PROPOSED TRAFFIC RESOLUTION

Reference: TR 11 - 17

Location: Barnard Street - Wadestown

Proposal: No stopping, at all times

Barnard St - Wadestown - TR (11 - 17) Proposed NSAAT Opposite # 55

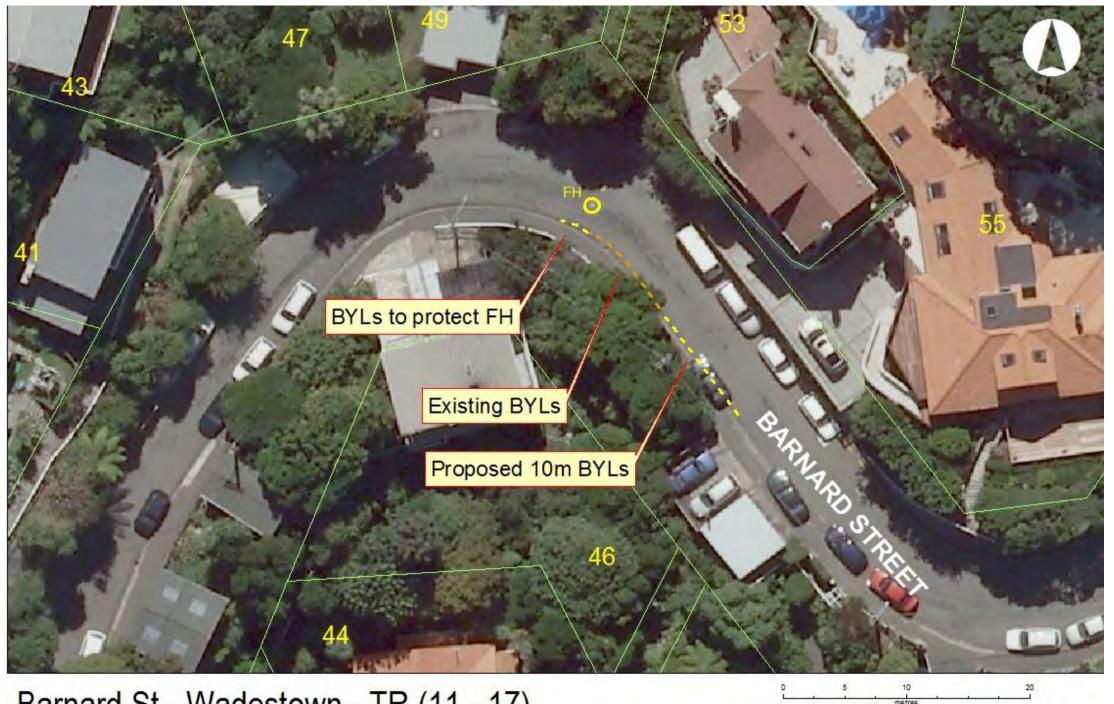
> to consider removing on-street parking on the western side of Barnard Street opposite # 55. Vehicles regularly park on both sides of this section of road leaving a narrow one lane for oncoming traffic. A "choke point" has now become apparent and there have been several minor incidents involving scrapes and broken mirrors at this location. This is a frustration

Therefore, Council officers propose to replace two parking spaces opposite #55 with a section of broken yellow lines (byls) to improve

Net parking loss: 2

Delete from Schedule D (No Stopping Restrictions) of the Traffic Restrictions Schedule

at all West side, commencing 161 metres North of its intersection with Lennel Road (Grid

X=1,749,218.6 m, 5,430,301.4 m), and extending in a southerly direction following the western kerb line for 8.5 metres.

Add to Schedule D (No Stopping Restrictions) of the Traffic Restrictions Schedule

No stopping, at all West side, commencing 158 metres North of its intersection with Lennel Road (Grid coordinates

> 1,749,218.6 *X*= m, 5,430,301.4 m), and extending а southerly direction following the western kerb line for 22 metres.
